Technical Bulletin

Torque Specs for Direct™ Plus, Flex, and Max

Preventative Maintenance Torque Check

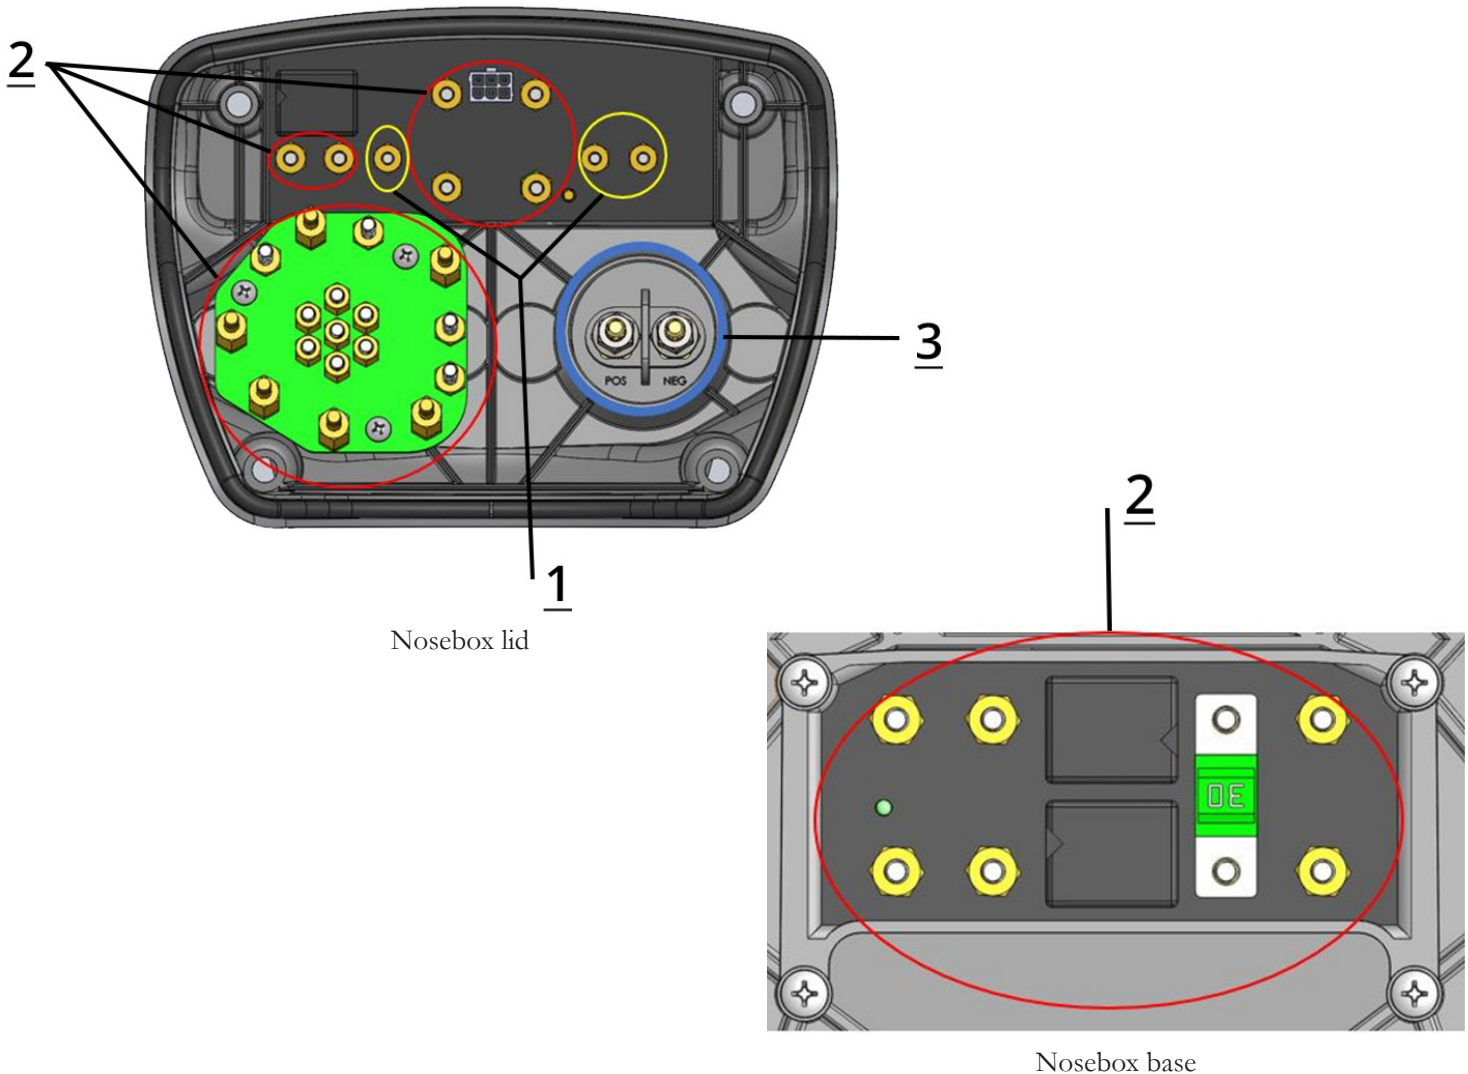
Purkeys would like to suggest that on all preventative maintenance checks or repairs to a Direct Plus, Flex, or Max, all threaded stud junctions be checked for proper tightness, as the nuts may loosen over time. To reduce the chance of loose fasteners, Purkeys has changed the design to incorporate Nylok nuts in future products.

The stud junctions shown below need to be checked. The minimum recommended torque specs are:

Call-out	Size	Recommended torque
1: circled in yellow	8/32	36 inch-lbs
2: circled in red	10/32	48 inch-lbs
3: circled in blue	1/4-20	60 inch-lbs
